S U B M I S S I O N : S I M M O N S
a written submission by way of objection to DA 2020/0318

Re:
48 The Serpentine, Bilgola Beach NSW 2107
DA 2020/0318

“the construction of alterations and additions to an existing dwelling including new double garage”

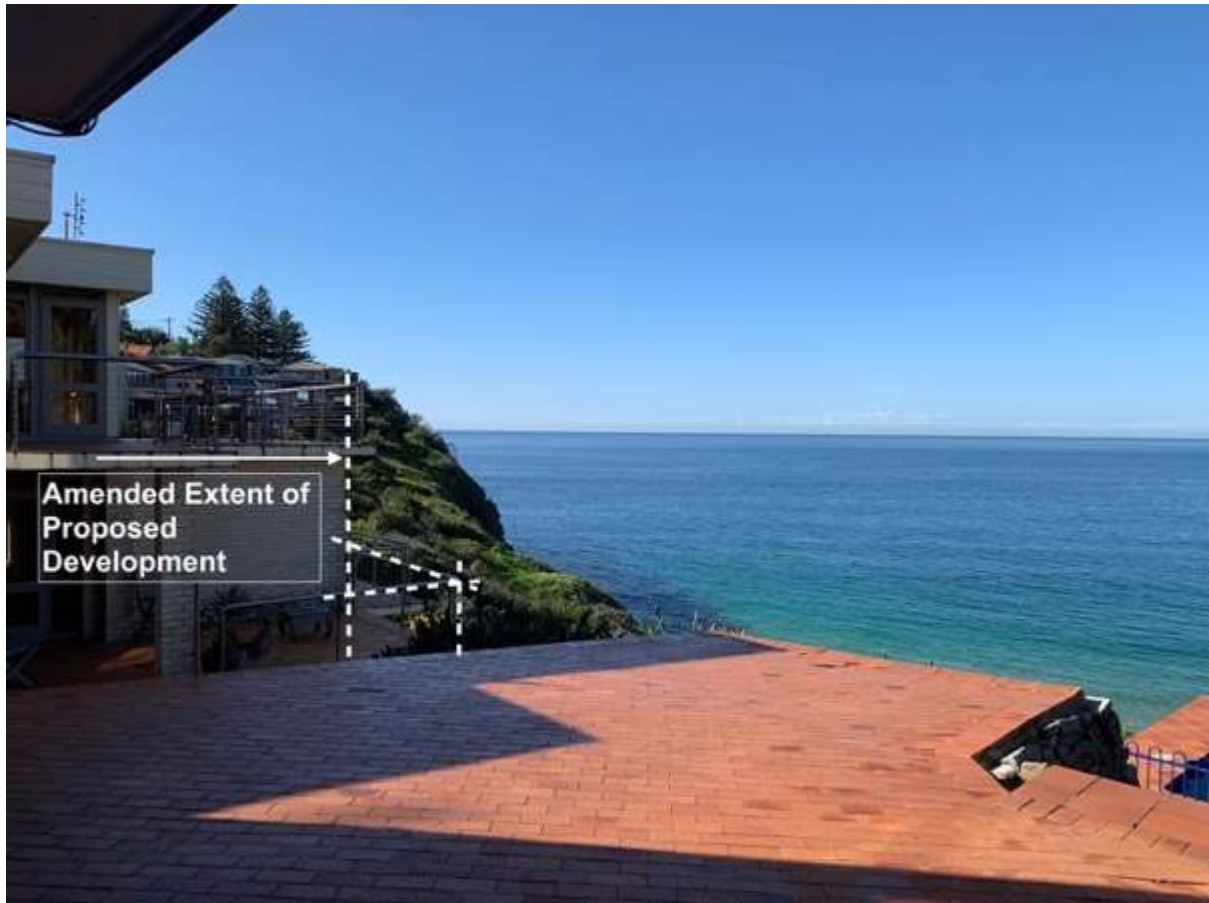
The applicant should have informed the design by a complete view loss consideration that would have clearly identified that any development extending to the south on the subject site would remove my sensational and highly regarded headland/water interface view-

There may be architectural solutions that maintain my view, by proposing development does not exceed past the alignment of the existing brickwork on the attached photograph. This would be a modest amendment, but would be highly appreciated and more reasonable, as it would maintain my headland/water face view.

View Loss Analysis: Proposed development must be reduced to ensure that the view available to the ocean side of the existing dwelling is maintained. Existing decks and balustrade to be retained at Bedroom Level as existing.

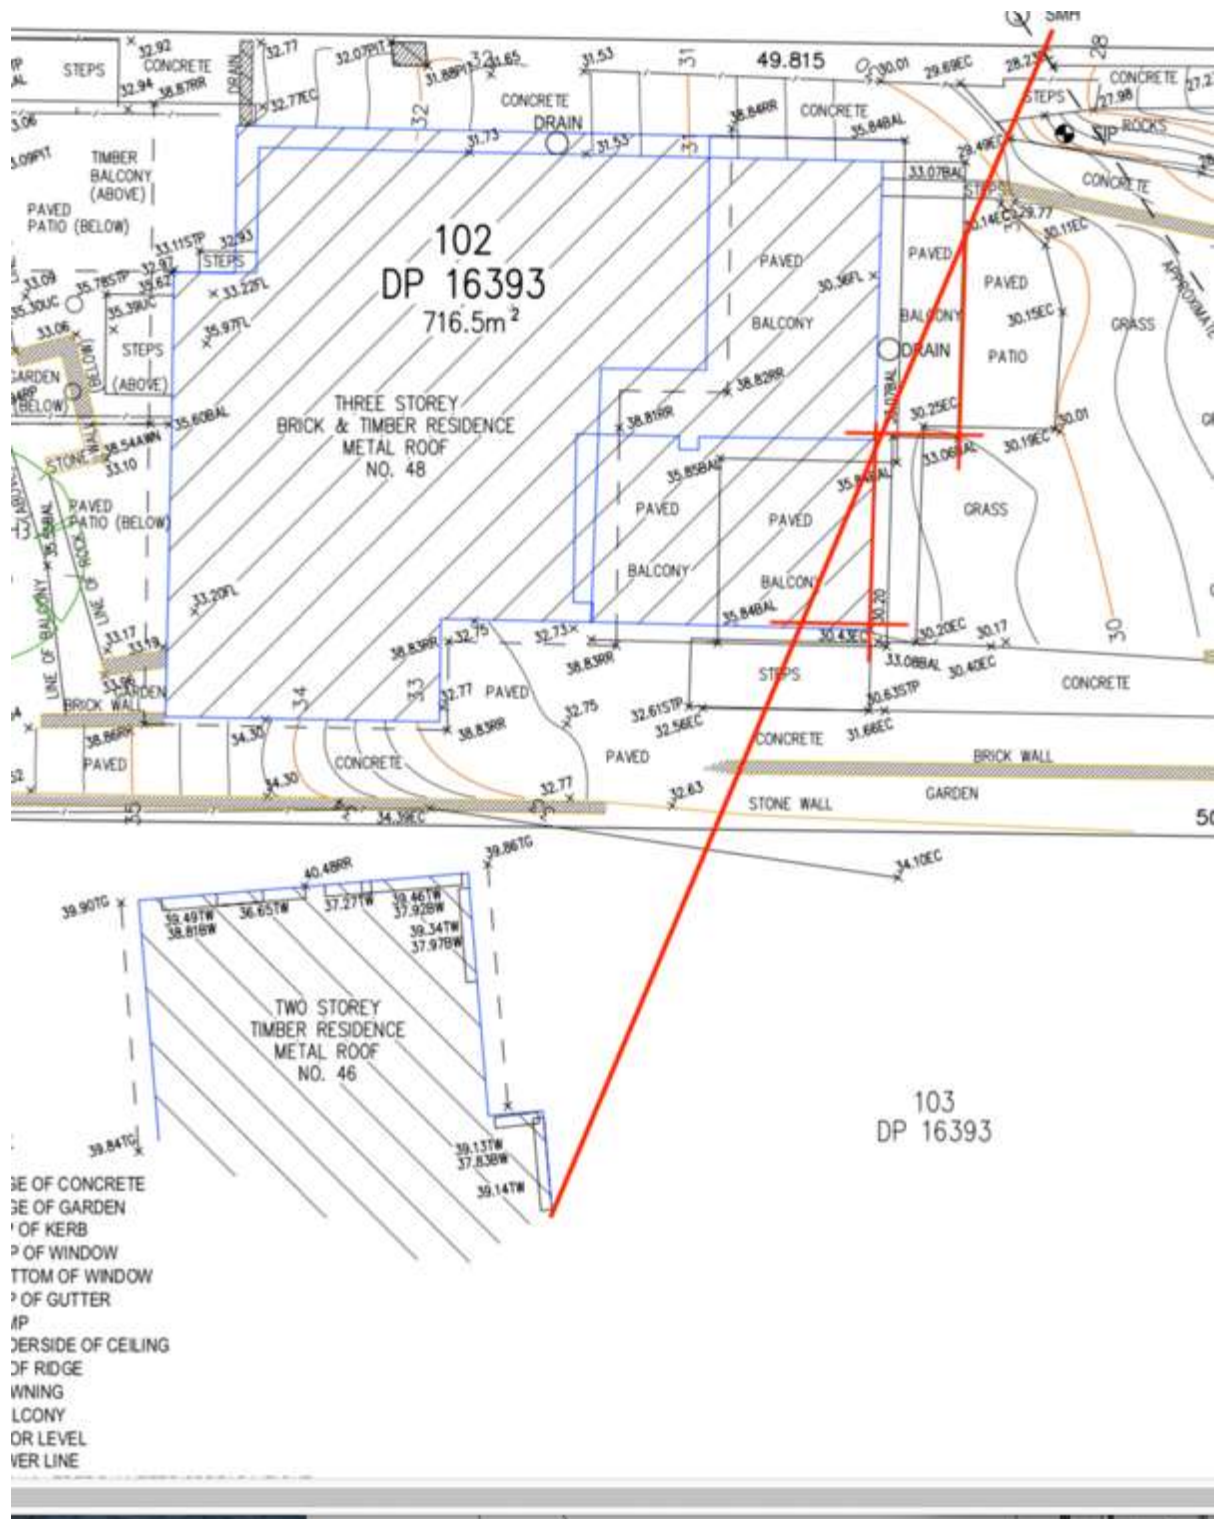
Proposed amended extent of proposed development: reduce the building envelope to be contained within the enclosure as marked. Headland & Ocean interface view to be maintained. A reasonable outcome would be to arrive at a massing model that does not extend beyond the viewing alignment of the brickwork wall at the Bedroom Level, and for that vertical alignment not to be exceeded at the Entry Level. This would require a modest adjustment to the layout. There may be other design opportunity to increase the envelope along this alignment, such that from my Living Room windows it could not be seen. I offer this as an added opportunity for the Applicant to perhaps slightly increase the envelope in zones that would not affect my headland view.

View Loss Analysis: Proposed development must be reduced to ensure that the view available to the ocean side of the existing dwelling is maintained.

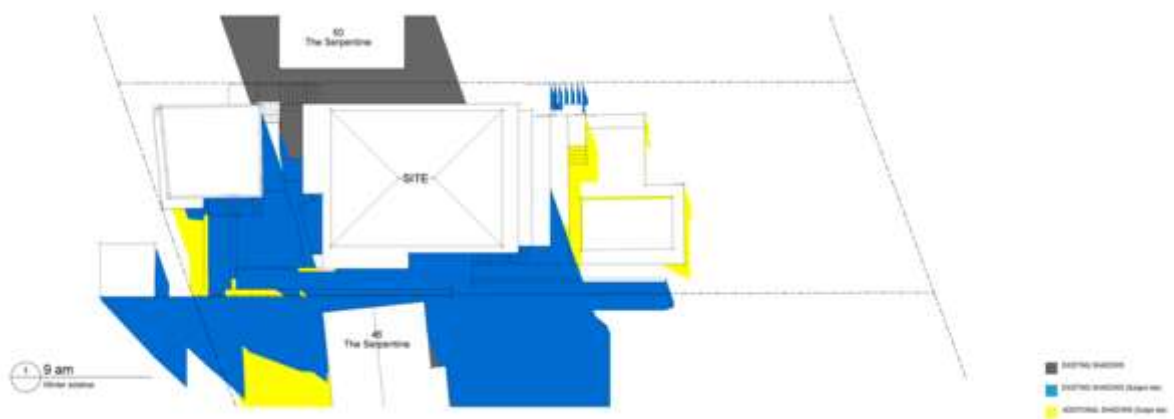
The diagram does not show any additional shadow to the south of my property facing the ocean.

The additional bulk in excess of the existing envelope will inevitable create additional overshadowing to my north/east and north/west facing windows.

The additional non-compliant envelope would inevitably overshadow my private open space, but this is not shown.

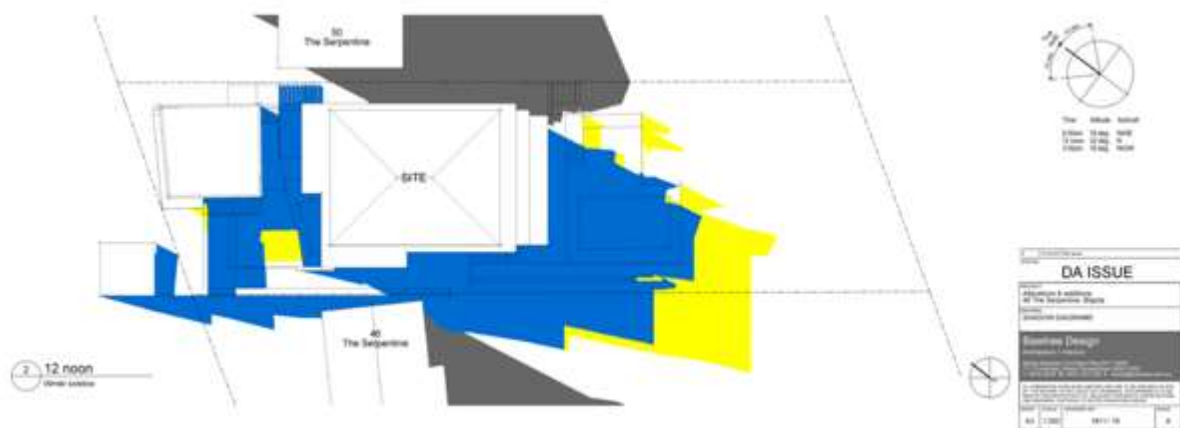
The Noon Winter Solar Diagram is incomplete.

My windows facing the development, up to noon, will be overshadowed.

The additional bulk in excess of the existing envelope will inevitable create additional overshadowing to north/east and north/west facing windows.

3pm Winter Sun Diagram by Applicant

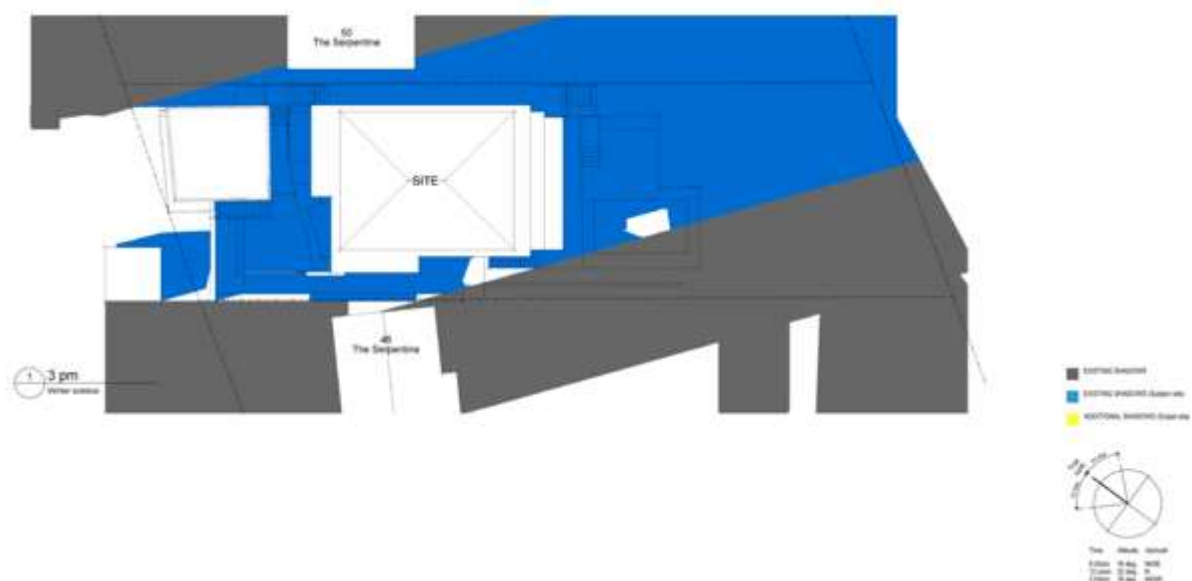
The 3pm Winter Solar Diagram shows that the solar angle from the proposed development leaves my property.

The diagram shows that there would be no solar access to my windows or ocean fronted private open space at 3pm.

The additional bulk in excess of the existing envelope will inevitable create additional overshadowing to north/east and north/west facing windows from noon to 3pm, and would create overshadowing to my south east facing private open space.

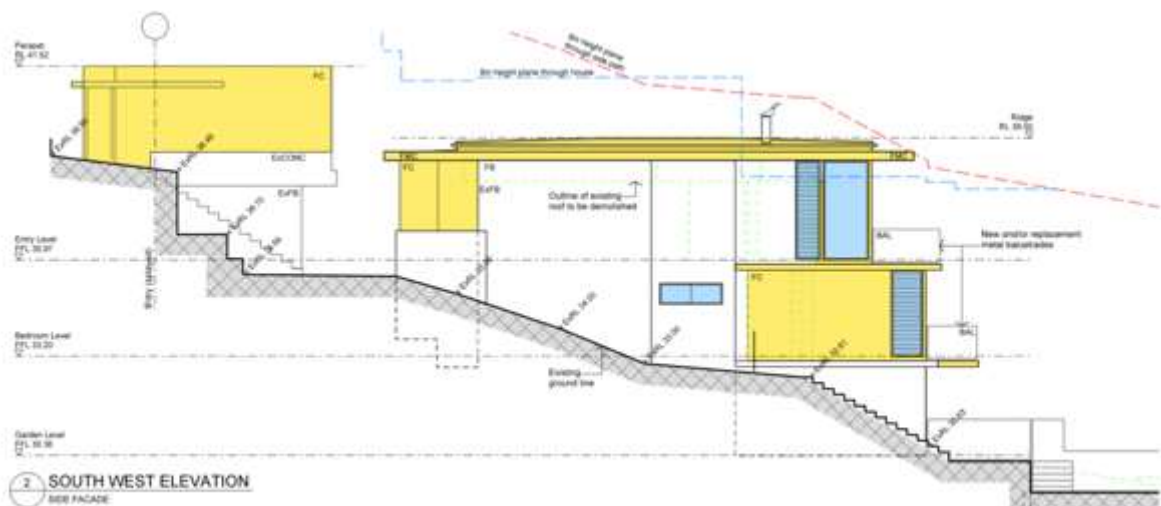
My concern also is to the extent of the west facing glazed areas in close proximity to my private open spaces and habitable rooms.

All windows directly facing my property need to be deleted or substantially reduced in size and require privacy screens.

D3.9 Building Envelope

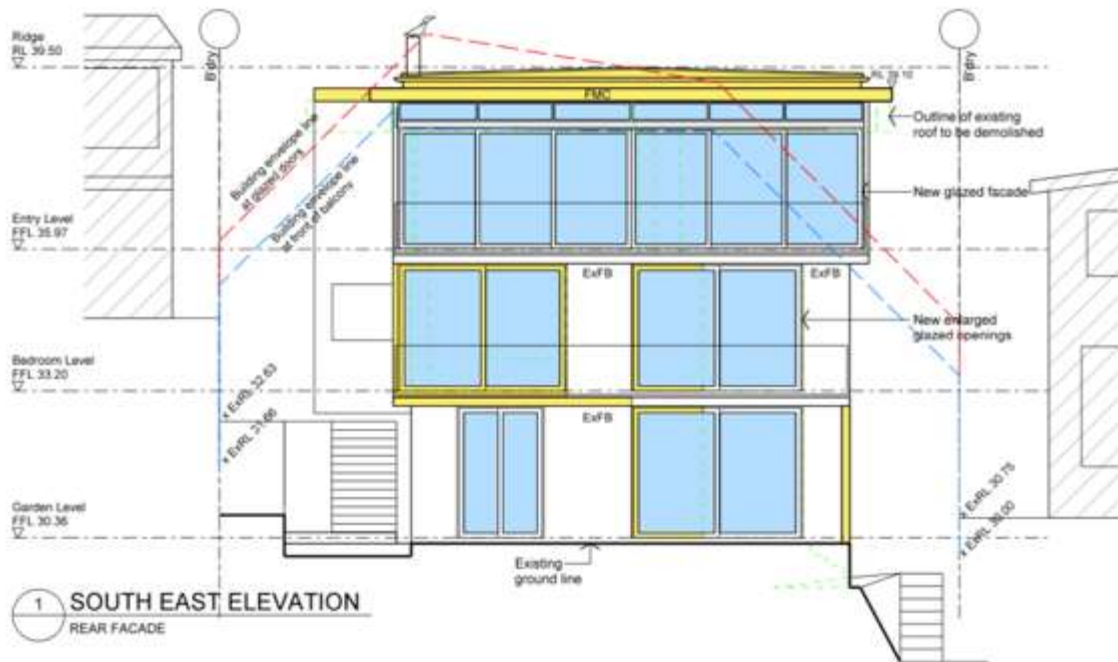
The 3.5m/45 degree building envelope is not maintained.

It is outside the control envelope.

Envelope represented in blue shows major non-compliance to control. Increased Setback to the Entry Level is required. Maximum building height not shown. The proposed three-storey component to the south-east is above maximum building height. Delete any further extension at the Upper Level to the south-east.

A. Entry Level @ 35.97:

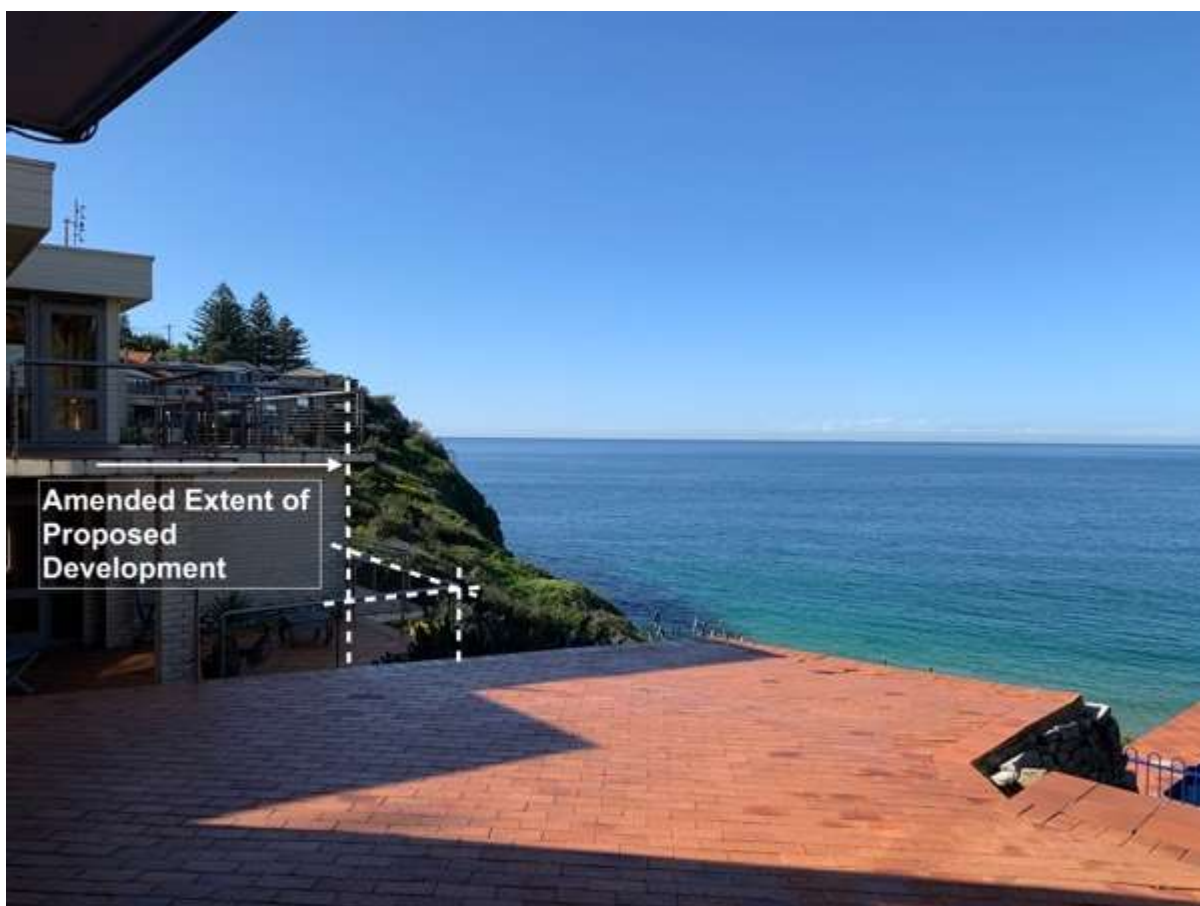
The south-easterly extension at this level is to be deleted. The roof height already exceeds the 8m maximum building height control.
